# Harnett County Department of Public Health

PERMIT # SFD 2501-0124

## Operation Permit

PROPERTY LOCATION: 54 Cultivator Ct, Angier

AS BUILT Revision

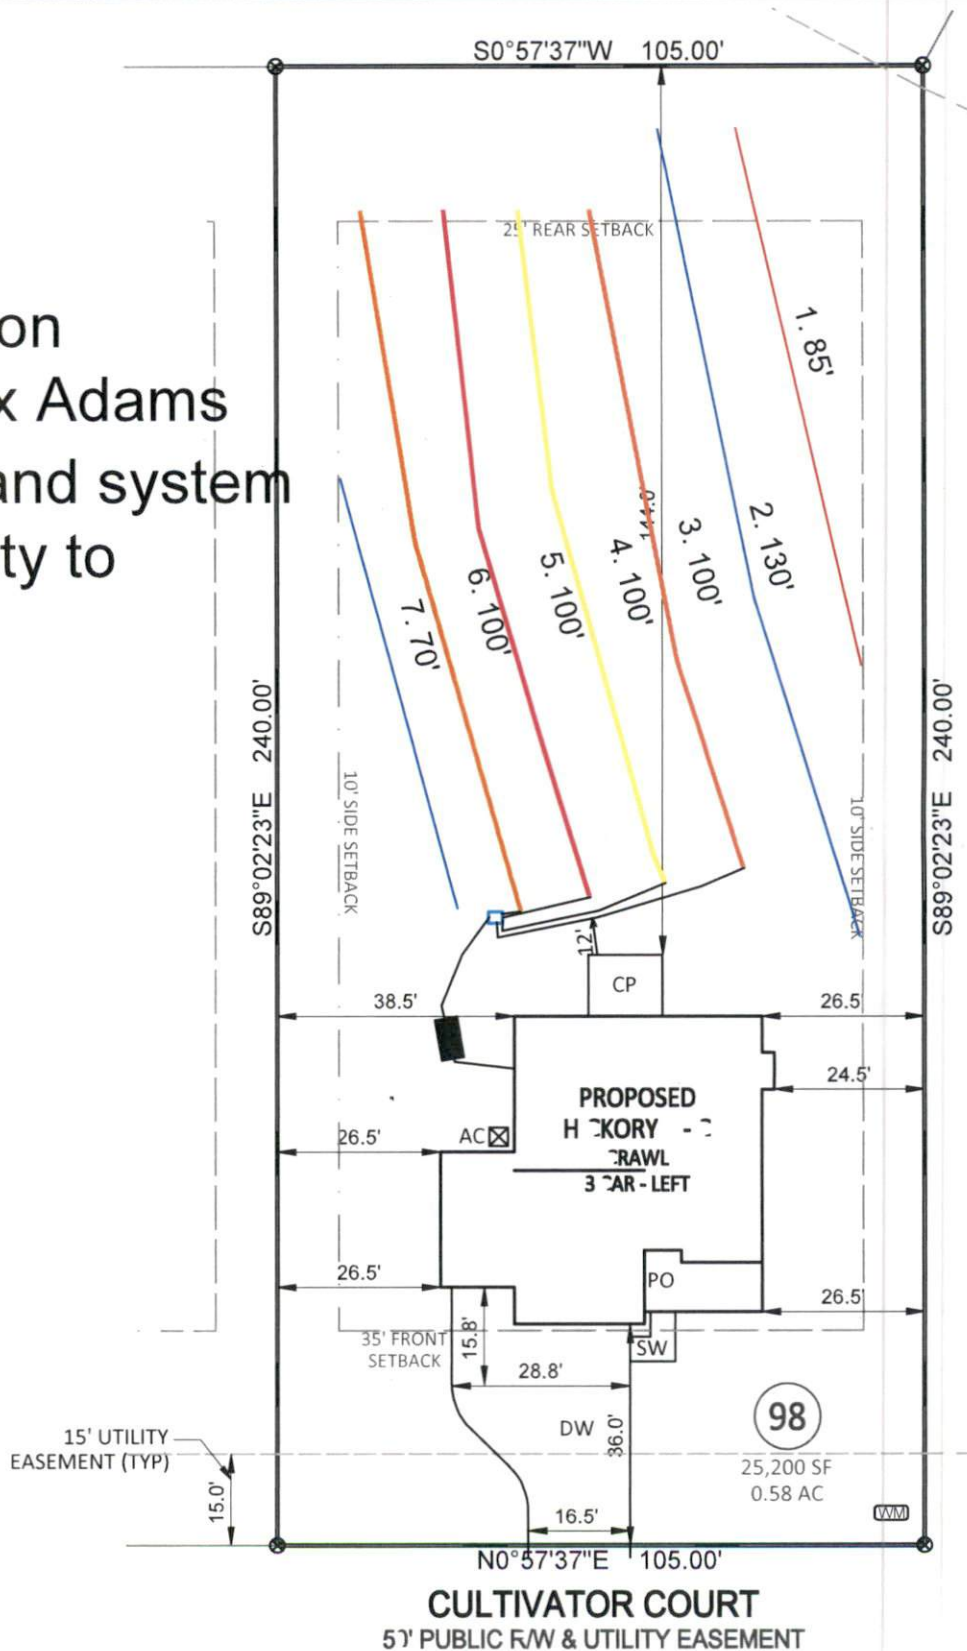
Pump removed and system  
changed to gravity to  
D-Box

\*House footprint to be field staked by surveyor  
and system verified prior to any construction

\*\*Septic area must not be altered by  
construction activities.

\*\*\*No cuts of 2' or greater within  
within 15' of septic area

\*\*\*\* Recommend protective barrier around  
septic field during construction.

\*If plumbing is not sufficient a  
pump tank will be required to  
septic field
